# Work Order ID 124139

Item ID: D350-607-511 Accept **\*N900040100\*** Setup Start **\*NS1\***  
 Revision ID: Stop **\*NS2\***  
 Item Name: Quick Release Basket Mounting Spacepod™ & Squirrel Cheek Fits LH or RH  
 Start Date: 9/02/14 Start Qty: 2.00 **\*2\*** Cust Item ID:  
 Required Date: 9/10/14 Req'd Qty: 2.00 **\*2\*** Customer:  
 Reference:

# DART SERVICE INSTRUCTION

TO AMEND INSTALLATION INSTRUCTIONS D350-607-3 Rev.D,  
INSTALLATION INSTRUCTIONS D350-607-4 Rev. C AND  
INSTRUCTIONS FOR CONTINUED AIRWORTHINESS ICA-D350-607 REV. 6  
REF TCCA STC: SH94-14  
REF FAA STC: SR00213NY  
REF EASA STC: EASA.10016996  
REF BRAZILIAN STC: 2007S03-03/-04/-05/-06

**FIGURE 1: INSTALLATION OF D4775-041 FWD STRUT**

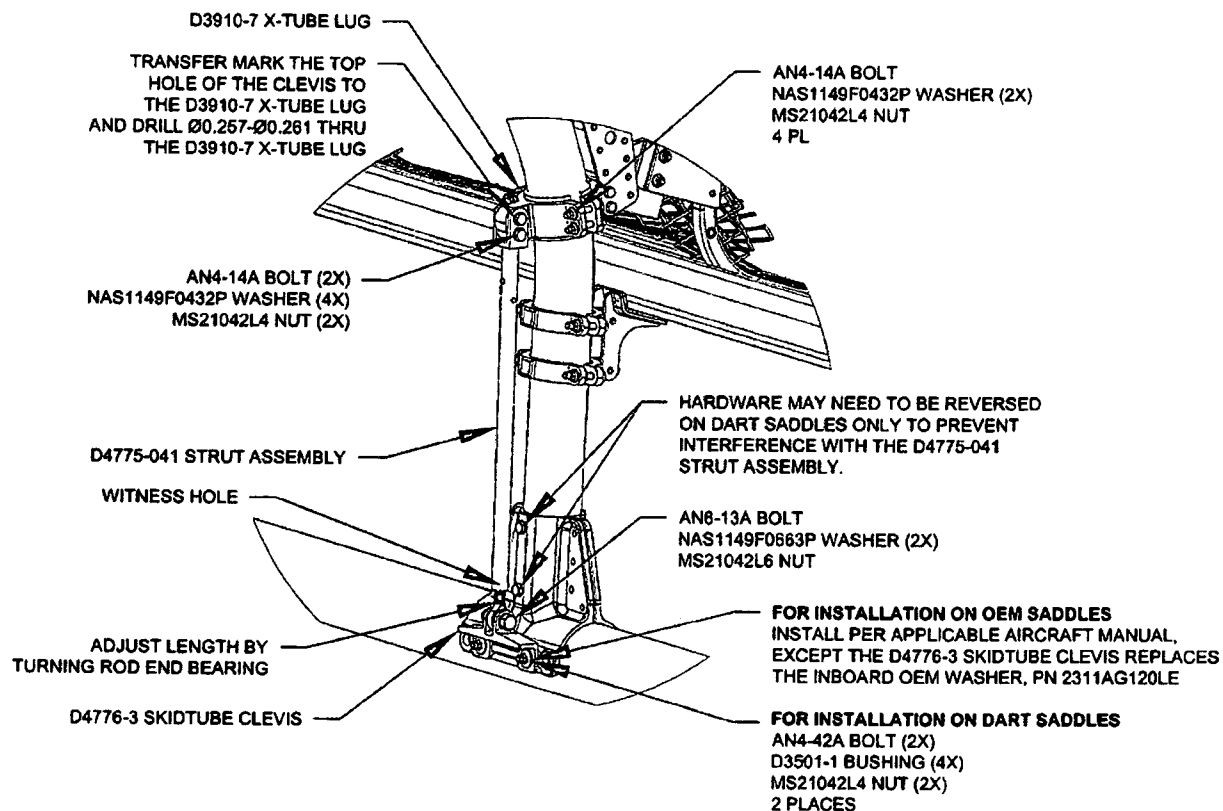
- 3.1 Substitute the Forward Lower D3910-5 X-Tube Lug with the D3910-7 X-Tube Lug as shown in Figure 1.
- 3.2 Install the forward D4775-041 Strut Assembly. Transfer mark from the upper hole on the clevis of the D4775-041 Strut Assembly to the D3910-7 X-tube Lug and drill thru the lug  $\varnothing 0.257$ - $\varnothing 0.261$  as shown in Figure 1. Touch up chemical conversion coating per MIL-DTL-5541. Check the witness holes located at the bottom end of the D4775-041 Strut Assemblies to ensure that the thread from the rod end extends past the witness hole.  
**Torque MS21042L4/-4 nuts to 50-70 in-lbs (5.7-7.9 N-m). Torque MS21042L6/-6 nuts to 160-190 in-lbs (18.1-21.5 N-m).**
- 3.3 Complete the installation in accordance with Installation Instructions D350-607-3 Rev. D or D350-607-4 Rev. C.

Modify the quantities for D3910-5 and add D3910-7 as follows:
